Nevro Corp.
Ex. 1002
U.S. Patent No. 7,891,085

RESPONSE TO NOTICE TO FILE CORRECTED APPLICATION PAPERS

In response to the Notice to File Corrected Application Papers -- Notice of Allowance Mailed, dated November 24, 2010, Applicants respectfully submit replacement drawings (5 figures, 2 sheets).

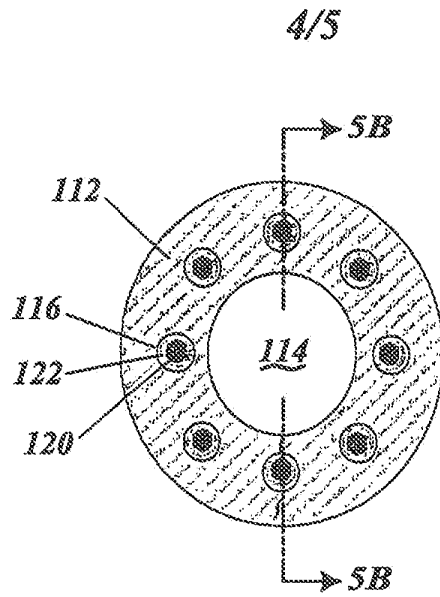
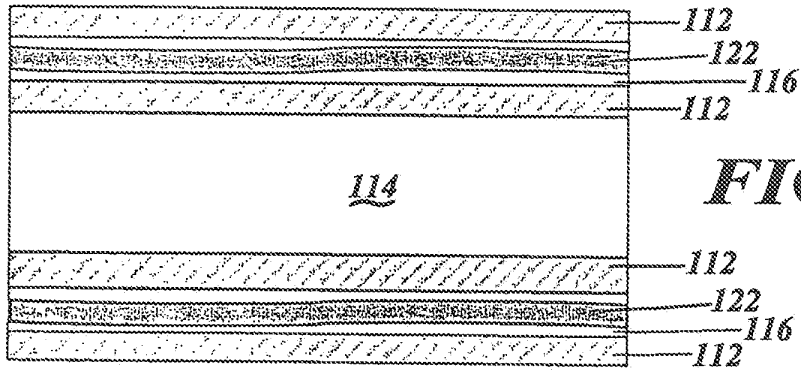
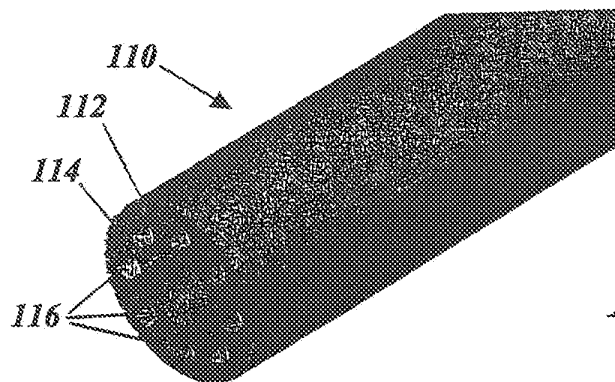
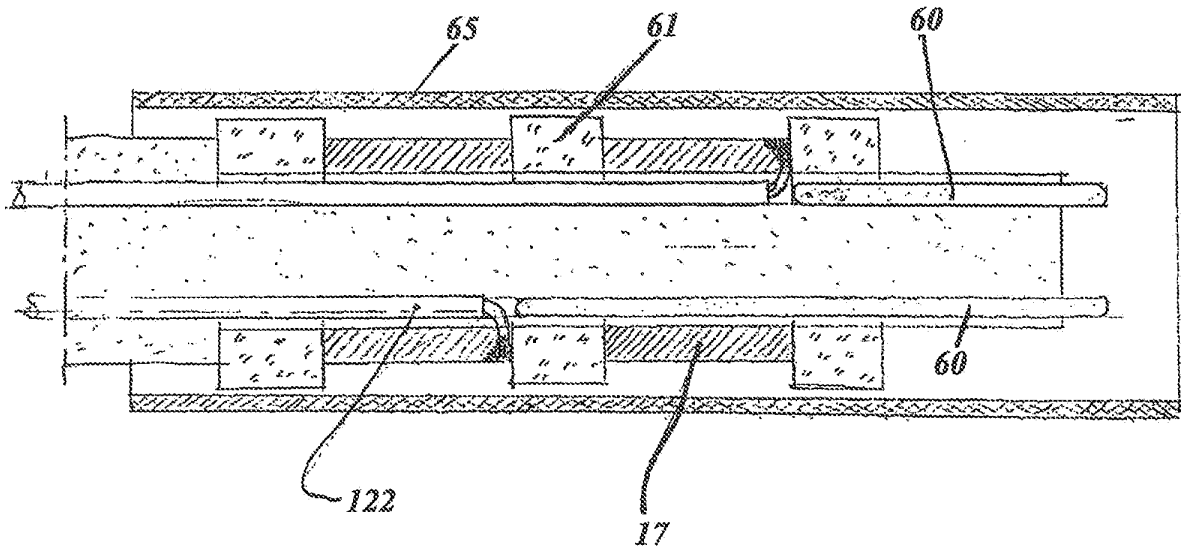
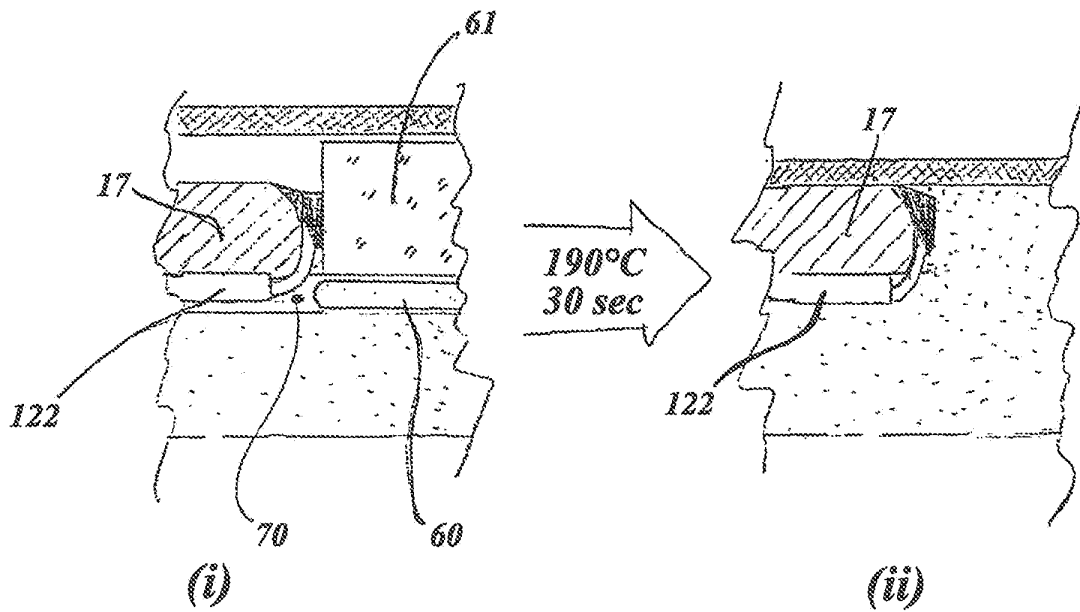
- Figure numbers are duplicated or missing. FIG(s)
- Drawing sheet or figure is missing. FIG(s)
- Numbers, letters, or reference characters in the drawing have been crossed out or are illegibly handwritten. FIG(s) 5a, 5b, 5c, 6a, 6b

- Figure numbers are duplicated or missing. FIG(s)
- Drawing sheet or figure is missing. FIG(s)
- Numbers, letters, or reference characters in the drawing have been crossed out or are illegibly handwritten. FIG(s) 5a, 5b, 5c, 6a, 6b
